Service Bulletin Number: CSP SB 20-20

Subject: New Diesel Particulate Filter Pressure Differential Sensor

Product Affected: X15e6 CM2350

Table 1: dP Sensor Tubes v SMA Assembly Part Number

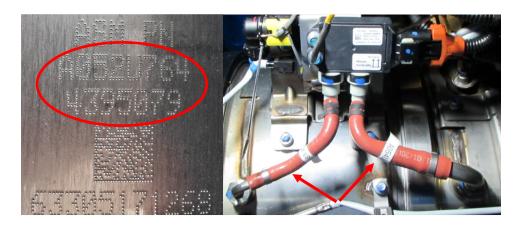
New sensor part number 5492073 has larger diameter tubes to reduce condensation build up and as such also requires the installation of larger diameter tubes.

Refer to table 1 below as to which differential pressure sensor tube part number should be ordered against the specific Single Module Aftertreatment (SMA) assembly part number. The SMA assembly part number can be found on the DEF mixer (decomposition) section.
